Date: 11 March 2019 Date of Issuance: 20 December 2018
Project Name: Lincoln Correctional Center Fire Sprinkler Upgrade Date of Opening: 19 March 2019
FE Project No.: 182029

FE #182029 Addendum No. 1 - Rebid

1. PRE-BID MEETING SIGN-IN SHEET.
2. PHOTOGRAPH OF STEEL PIPE PROTECTION.

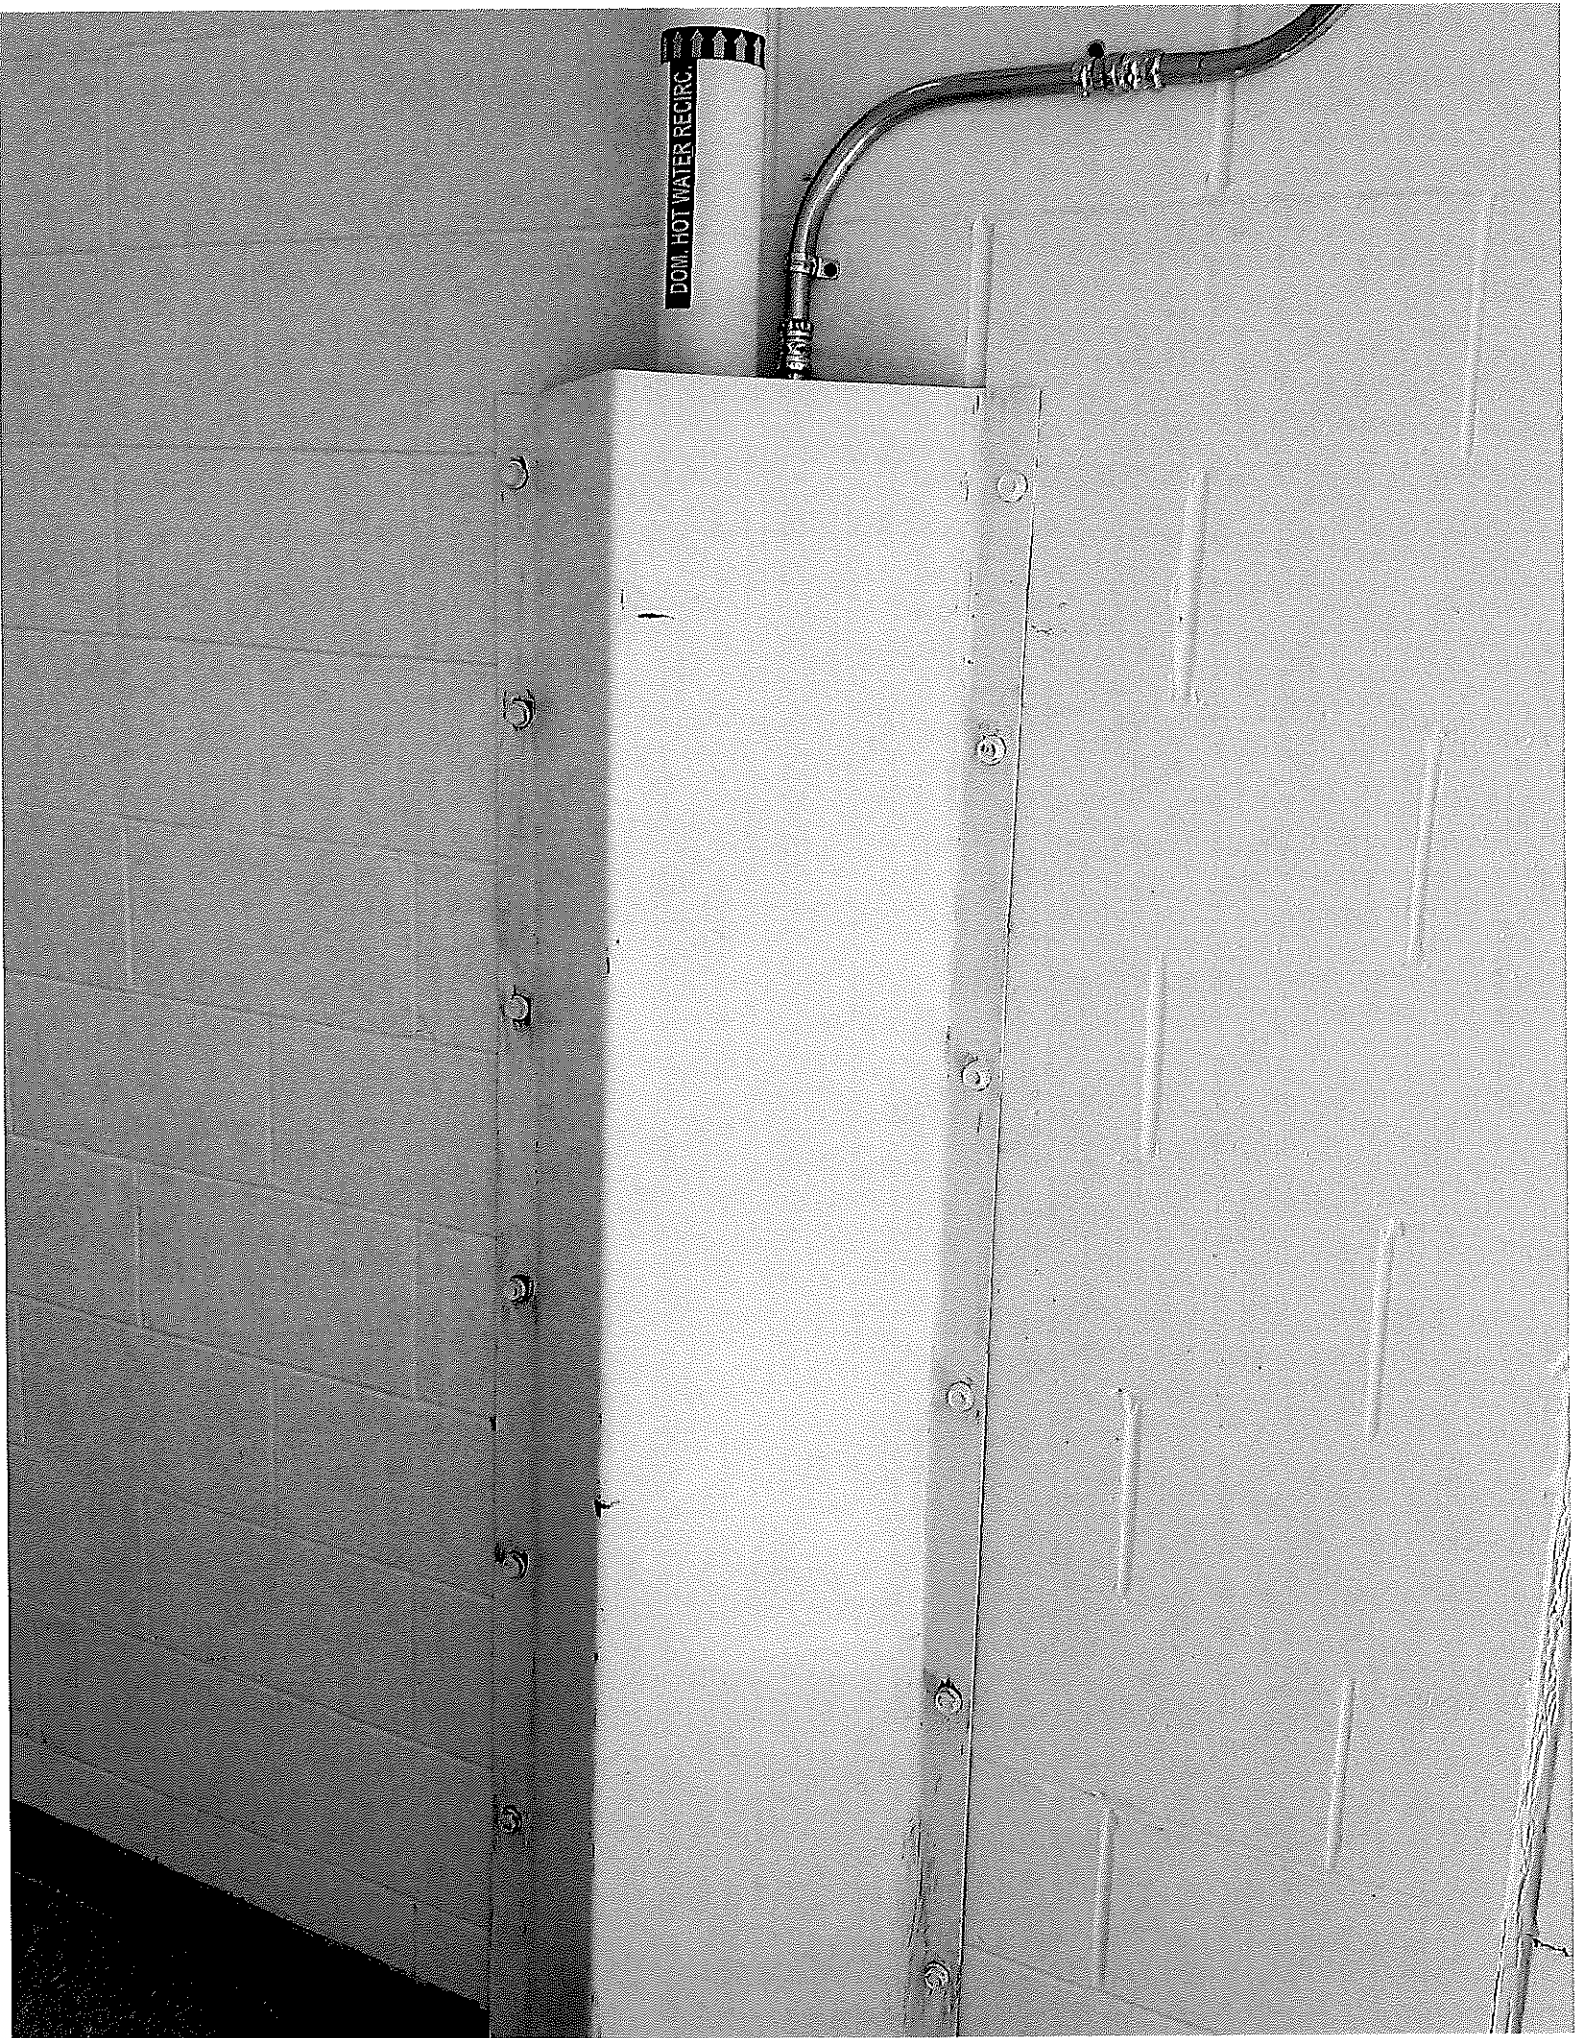
1. Fx200 – LCC COMPOSITE LEVEL ONE FIRE SUPPRESSION PLAN:
 - A. Add the following to the end of General Keynotes Number 1: “WHERE NECESSARY TO ROUTE PIPING FROM SPACE BELOW WALKWAY TO UPPER LEVEL OF WALKWAY, PROVIDE 16 GAUGE STEEL PROTECTION FROM FLOOR LEVEL TO A HEIGHT OF 7'-2" ABOVE FINISHED WALKWAY TO PROTECT PIPING FROM DAMAGE. PIPE PROTECTIVE COVER SHALL BE SECURED TO THE WALL USING LAG BOLTS SIMILAR TO WHAT IS SHOWN IN ATTACHED PHOTOGRAPH. SEE ATTACHED PHOTOGRAPH FOR EXAMPLE OF PROTECTION EXPECTATIONS.
